ENQ/2025/01243

Site: GASPER FARM, GASPER STREET, GASPER, STOURTON, WARMINSTER, BA12 6PY

Officer: Jonathan James

SUMMARY

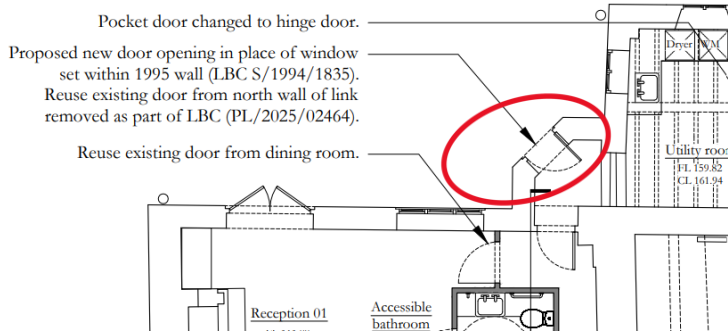
No objection. This is clearly a modern structure which detracts from this part of the façade, as noted in the heritage statement.

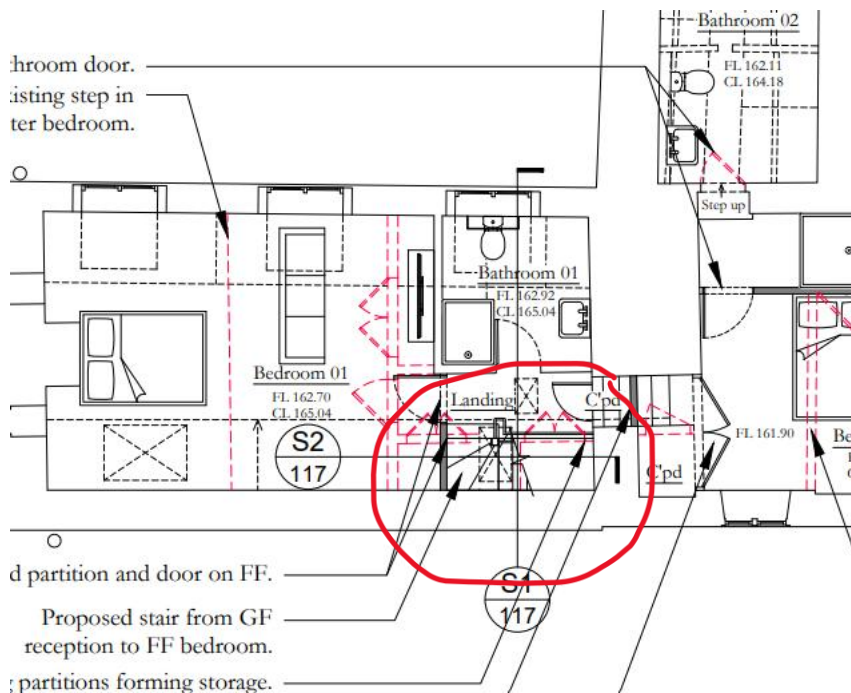
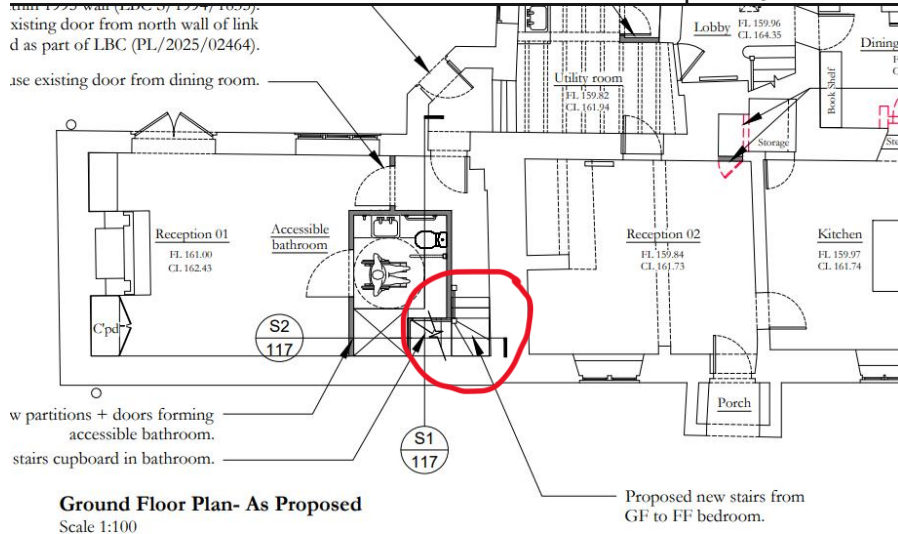
This is within a modern extension to the original farmhouse. As such, I have no objection.

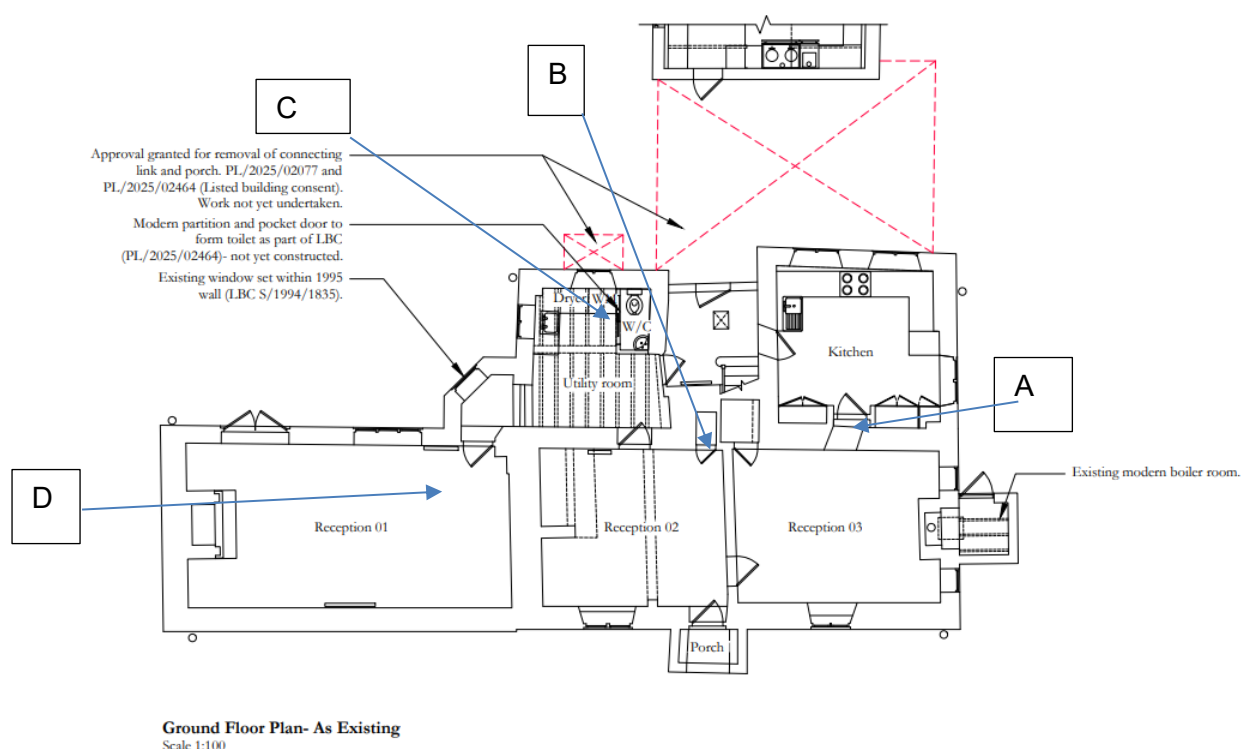
In light of the above, ie that this is an open sided barn converted to residential, I raise no objections.

Proposed changes – ground floor

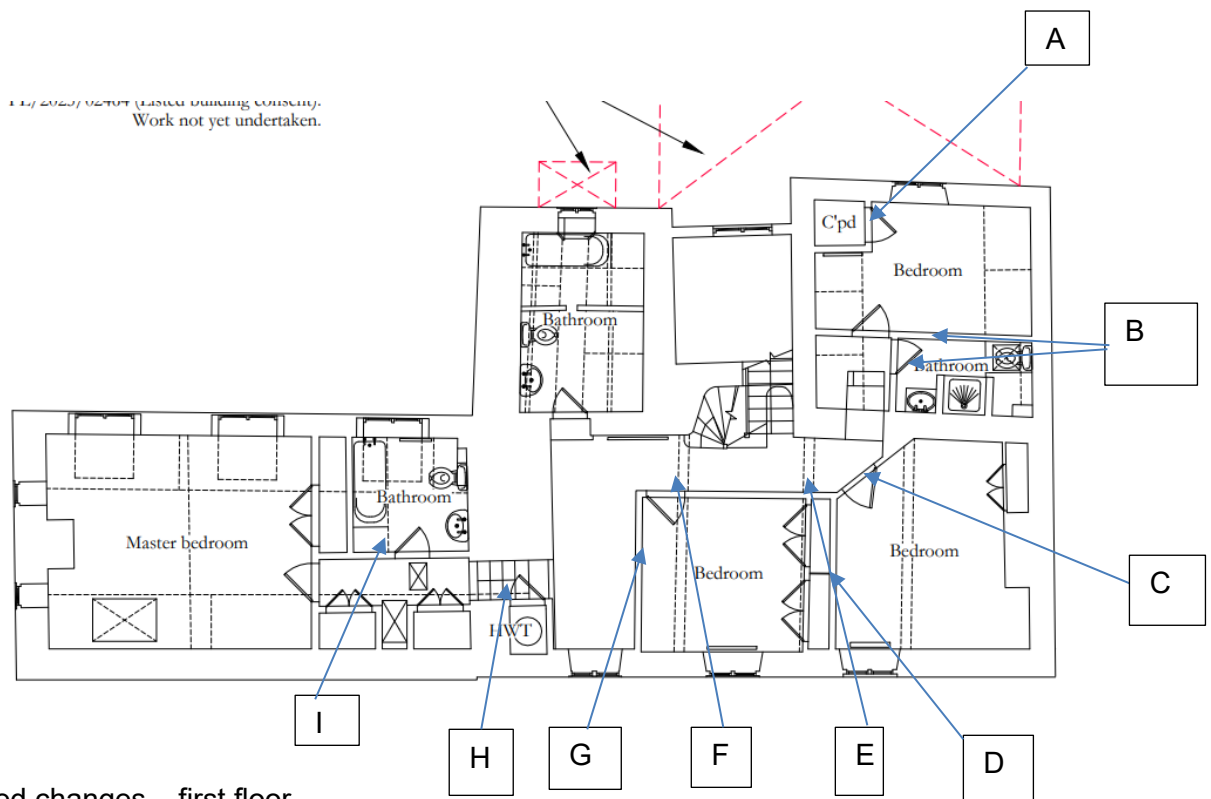
- A – remove existing door and partition
- B – remove door and block opening
- C – pocket door to hinge door
- D – re-use existing door from dining room (in conjunction with new downstairs WC)

I have no objection in principle, however, a heritage impact assessment should include photos of doors A and B to evidence whether they are of historic interest.

Attic Floor Plan- As Existing
Scale 1:100

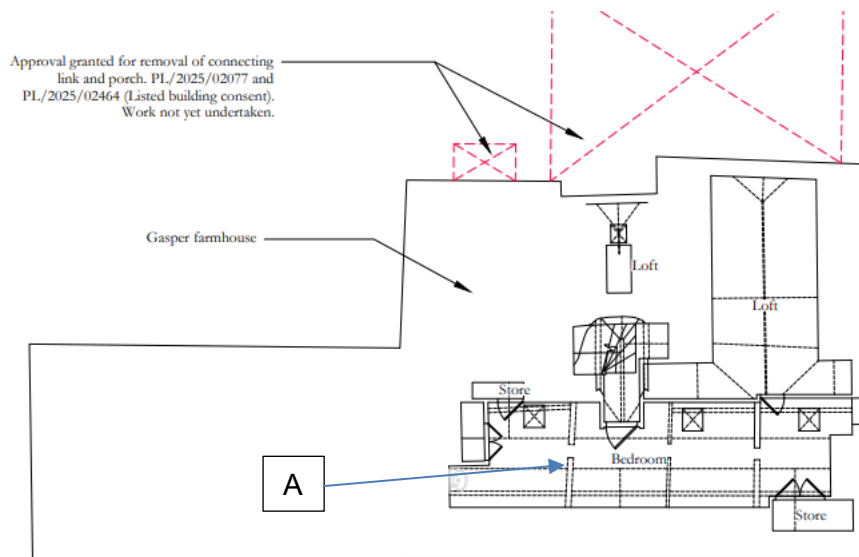
A – proposed partition and door to back of truss to form bathroom

Isn't there a partition there already? What is the nature of this partition? I note the PHA justification says 'Form ensuite with new partition and door behind the truss line'. It doesn't mention the existing ie whether it is historic. I would require further justification of this.
